Record of Executive Business and Chief Executive's Order

Reg. Reference: SD21A/0314 **Application Date:** 18-Nov-2021
Submission Type: Additional **Registration Date:** 11-Mar-2022
Information

Proposed Development: Construction of two 2-storey semi-detached 2-bedroom dwellings with vehicular entrance from Templeroan Way; all associated site, landscaping, boundary and ancillary works.

Location: 48, Templeroan Way, Knocklyon, Dublin 16

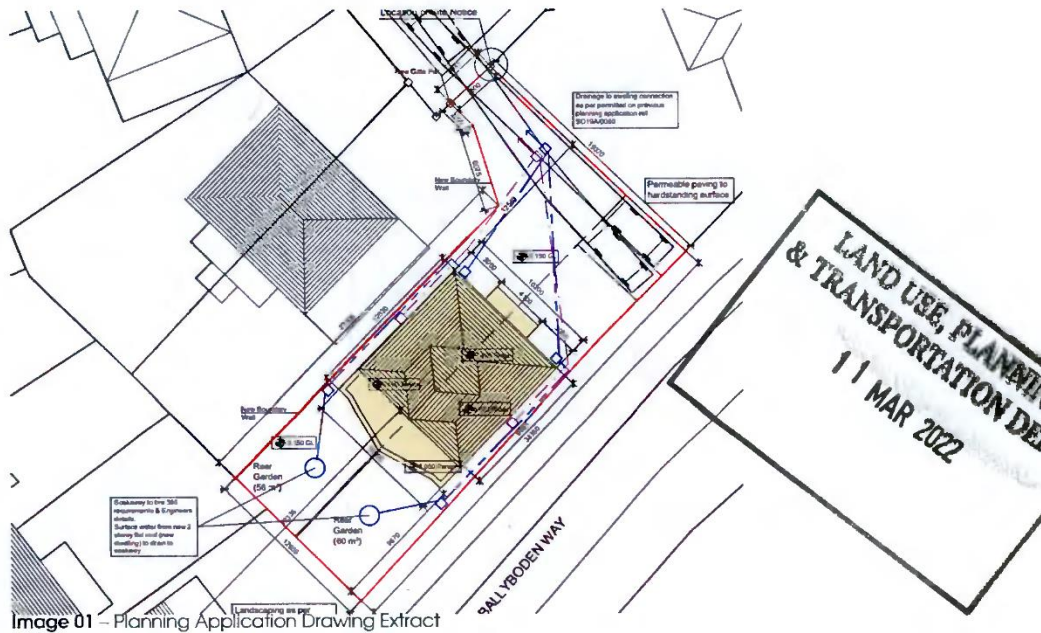
Item 1: Roads Requirements

The applicant has submitted a cover letter and revised drawings in an attempt to address the request for additional information. An extract taken from the cover letter states the following:

Item 1(a).

- a. We would note that No. 48 Templeroan Way is not in our clients ownership. Our clients property ownership extends only to the site outlined in red. Therefore it is our understanding that the drawings as submitted in the planning application to date are correct. This is now submitted at 1:100 Scale

The applicant has clarified that the existing dwelling No. 48 Templeroan Way is not within the red line boundary.
